CHANGE AFFECTING TENSIONING PULLEY 55282

TECHNICAL INFO NO. 1112

Ford	Fiesta, Focus, Mondeo
Mazda	2
Volvo	C30, S40, V50

Image 1: Top: the two previous versions with red or black seal. Bottom: the new version

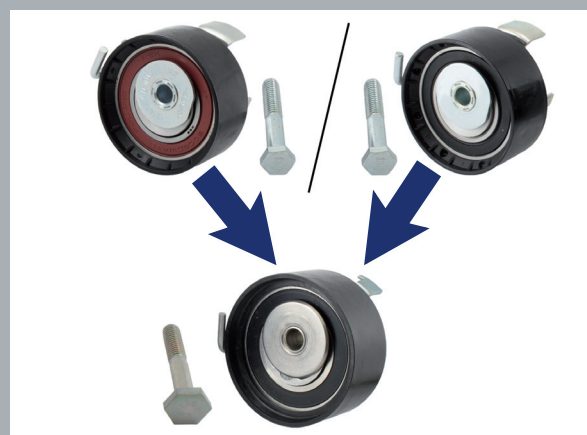
When installing the modified tensioning pulley, the enclosed fixing bolt M8x46 must be used. As the screw hole has changed, it is not permitted to use mixed components.

As part of our continuous efforts to improve our products, modifications have been made to tensioning pulley 55282 and the associated fixing bolt.

This Technical Information sheet shows the visual features of the previous versions (Figure 1, top) and the new version (Figure 1, bottom).
